STAFF RECOMMENDATION
208-210 Broadway
October 19, 2016

Application: New construction-partial demolition
District: Broadway Historic Preservation Zoning Overlay
Council District: 19
Map and Parcel Number: 09306211100
Applicant: Reggie Parsons, Ehrlich Design Builders
Project Lead: Robin Zeigler, robin.zeigler@nashville.gov

**RE: Redneck Riviera / 208-210 Broadway / Nashville, Tennessee
EMC Project No. 16310**

Figure 2: This image shows 210 Broadway in the middle and 208 Broadway to the right with its original 3rd story.

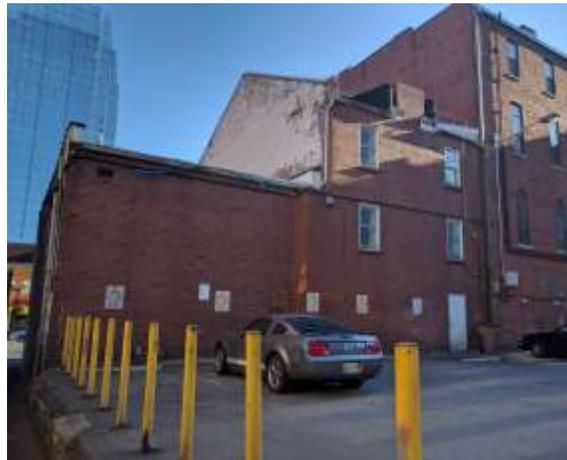
The portion of the wall to be reconstructed was historically an interior wall as shown on an earlier photograph. See Figure 2. For this reason alone, staff recommends approval of reconstruction of the wall with brick salvaged from the project finding the project to meet section V.5.

Staff recommends approval of the reconstruction of the right-side wall with brick salvaged from the project and with the exact same dimensions and design as the current wall, finding the partial demolition meets section V.5 of the design guidelines.
